UNITED STATES PATENT AND TRADEMARK OFFICE

APPLICATION NO.	FILING DATE	FIRST NAMED INVENTOR	ATTORNEY DOCKET NO.	CONFIRMATION NO.
10/671,291	09/25/2003	George Liang	2003P14216US	4268

Office Action Summary

DETAILED ACTION

Fig. 13

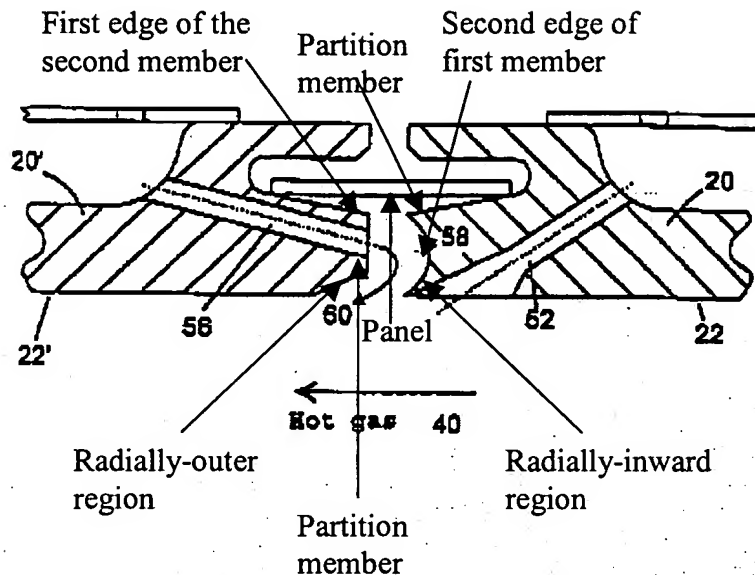
Regarding claim 1: Anderson discloses an outer air seal assembly (seal assembly of figure 13) for reducing leakage proximate a fluid guide component having a predetermined direction of rotation (rotation of turbine component inside 20 and 20', intended use). The seal assembly comprising a first boundary member (20) radially spaced apart from a central axis by a predetermined first distance (distance from axis where gas is flowing), the first boundary member characterized by a first interface edge and an opposite second interface edge (first edge near gap 58 and opposite second interface edge opposite of the first edge), a second boundary member (20') radially spaced apart from the central axis by a predetermined second distance, the second boundary member being characterized by a first interface edge and an opposite second interface edge, the second boundary member first edge being disposed proximate the first boundary member second edge and space apart therefrom by an interface gap (gap 58) disposed therebetween and the interface gap includes a radially-skewed portion having a radially-inward region (radially-inward region of 20' that forms a part of the interface gap) and a radially-outward region (radially-outward region of 20 opposite of the radially-inward region), the

Regarding claim 2: The interface gap (58) separates the first and second boundary members circumferentially.

Regarding claim 3: The seal assembly further including a blocking panel disposed within the interface gap (panel similar to 16 blocking the interface gap 58).

Regarding claim 7: A partition member (as showed in attached figure 13) extending into the interface gap, wherein a serpentine-shaped pathway is formed within the interference gap (this is the case since two partition members are there and it forms a serpentine shape pathway).

Regarding claim 8: The partition member is disposed on the first boundary member (see attach figure).

Regarding claim 9: The partition member is disposed on the second boundary member (see attached figure).

Regarding claims 12-13: The first boundary member further includes a radially inward surface (inward surface that has the partition) and a conduit (52) adapted to fluidly connect a source of cooling fluid to the interface gap, whereby the interface gap is adapted to deliver the cooling fluid to the location proximate the radially inward surface (as seen in the attached figure). The conduit is fluidly connected to the radially skewed portion.

Regarding claims 14-15: The second boundary member further includes a radially inward surface (inward surface that has the partition) and a conduit (56) adapted to fluidly connect a source of cooling fluid to the interface gap, whereby the interface gap is adapted to deliver the cooling fluid to the location proximate the radially inward surface (as seen in the attached figure). The conduit is fluidly connected to the radially-skewed portion.

Regarding claims 16-20: The first and second boundary members have a radially inward surface (surfaces having the radially-inward region and the radially-outward region). The interface gap separates the first and second boundary members axially (as seen in attached figure). The seal assembly further including a radially aligned region (regions adjacent to the partitions) disposed radially-outward of the radially skewed portion.
